KNOXVILLE HISTORIC ZONING COMMISSION STAFF REPORT - CERTIFICATE OF APPROPRIATENESS APPLICATION

PROPERTY ADDRESS: 605 Caswell St 37917

FILE NO.: 9-O-17-HZ

LEVEL OF WORK: Level II. Major repair or replacement of materials or architectural elements

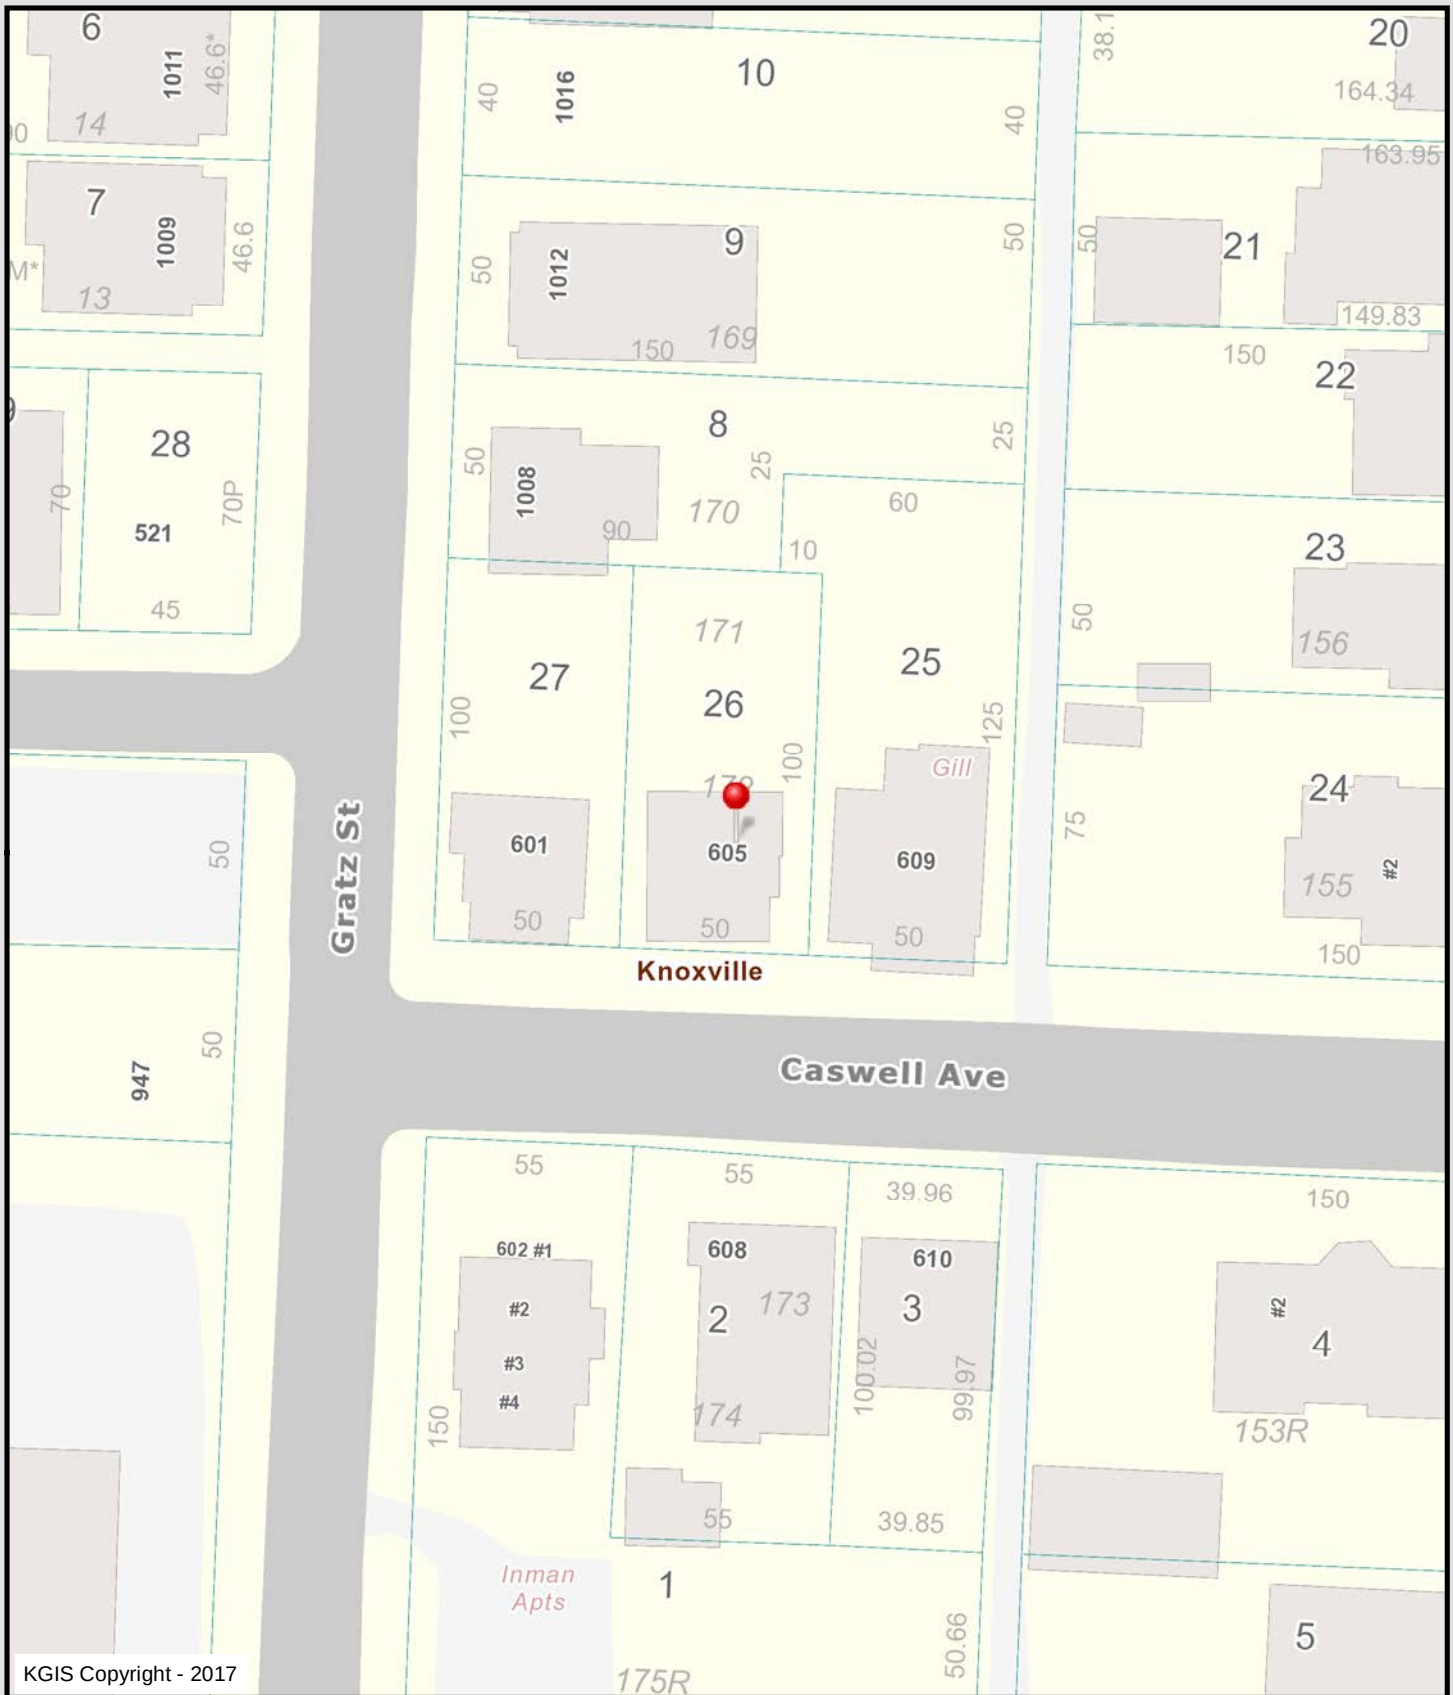
1. The house is a contributing structure within the Fourth and Gill H-1 Overlay and the National Register Historic District.
2. The documentary photo from the early 20th-century indicates 1/1 double-hung windows and no decorative sawnwork or other ornamentation on the structure. The historic inventory dating 1990 does not indicate any original ornamentation, except for imbricated fishscale shingles in the gable, and the house is similar to many other simple, unembellished Queen Anne houses in the district.

5. It is staff's opinion that the multi-light stained-glass door would be decoratively conjectural and would not comply

with the SIS guideline that states: "Changes that create a false sense of historical development, such as adding conjectural features or architectural elements from other buildings, shall not be undertaken."

6. There is physical evidence on the house in its change of siding type and window height to indicate that a transom existed over the entry door, and this is a very typical and common characteristic of Queen Ann entries. As the entry exists without its transom and with a shortened entry door, the original proportion and scale of the entry are distorted and not proportionate to the house.

Approval of all above-mentioned improvements to the house except for the proposed front door. The multi-light and stained glass type of door panel is not documented to have ever been utilized for this era of house or in Knoxville's historic neighborhoods.
